Project Name: Parcel # 2035, 1806, 95989

Location: Hamlets Chapel Road/Pleasant Springs Road

Project Number WP-24-17

Subject Features: Three (3) ephemeral segments, three (3) intermittent segments, one (1) perennial segment, six (6) potential wetlands, and one (1) beaver impoundment

Site Visit 3/21/2024
Drew Blake - Chatham County
Watershed Protection Department

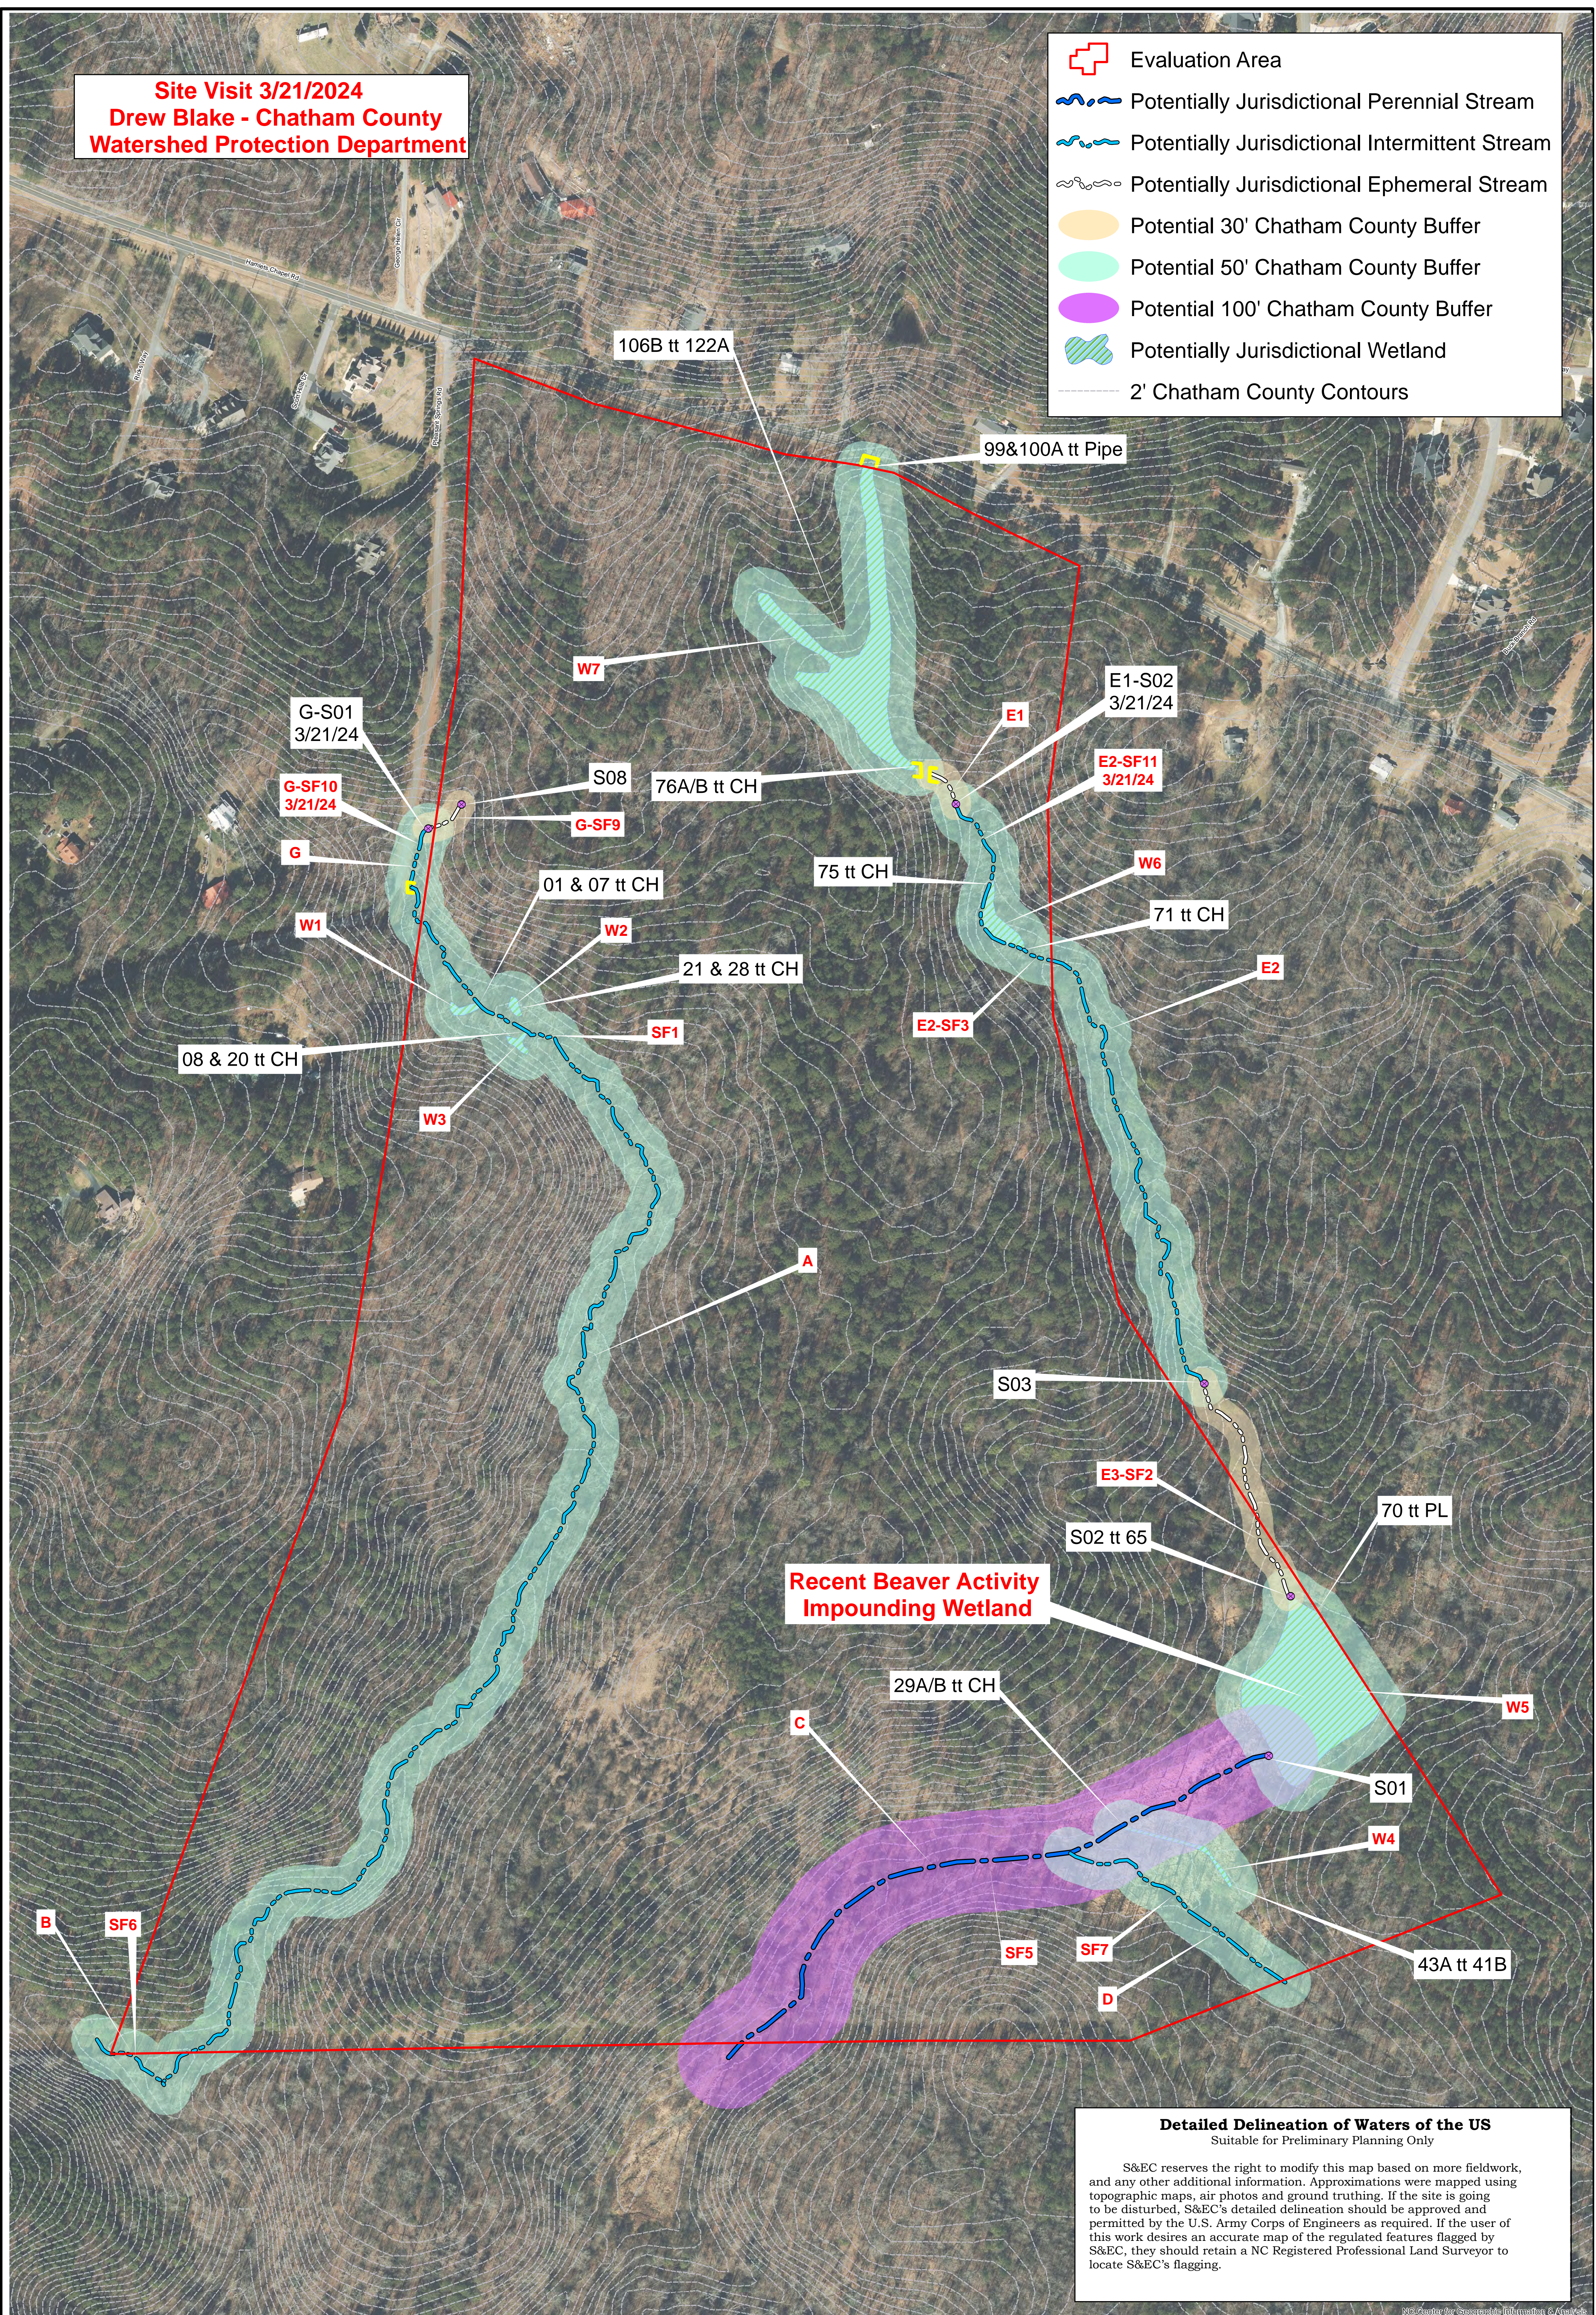
During the site visit, Chatham County staff determined that one identified ephemeral stream (SF8) did not meet the definition of an ephemeral stream as defined in Section 109 of the Chatham County Watershed Protection Ordinance. The start and end points of two ephemeral segments (E2-SF11 and G-SF10) were relocated in during the site visit. Wetland (W5) was determined to be a beaver impoundment during the site visit.

**Recent Beaver Activity
 Impounding Wetland**

The riparian buffer shall be fifty (50') feet landward, measured horizontally on a line perpendicular from the delineated boundary, surrounding all features classified as wetlands and linear wetlands. **The potential wetlands identified by S&EC have not been confirmed by the US Army Corps of Engineers. Once the USACE confirmation is received the 50-ft riparian buffers will be required from the flagged confirmed wetland boundaries.**

Beaver impoundments are streams dammed up by beaver activity. Therefore, if the stream that is now a beaver impoundment shows on either the USGS Topo or the most recent version of the soil survey map, the beaver impoundment should be treated as an open water since it is a pond in the intent of the rules and must have a 50-ft protected riparian buffer around its perimeter measured from the elevation of the beaver. Streams coming into or out of a beaver pond also have a 50-ft protected riparian buffer.
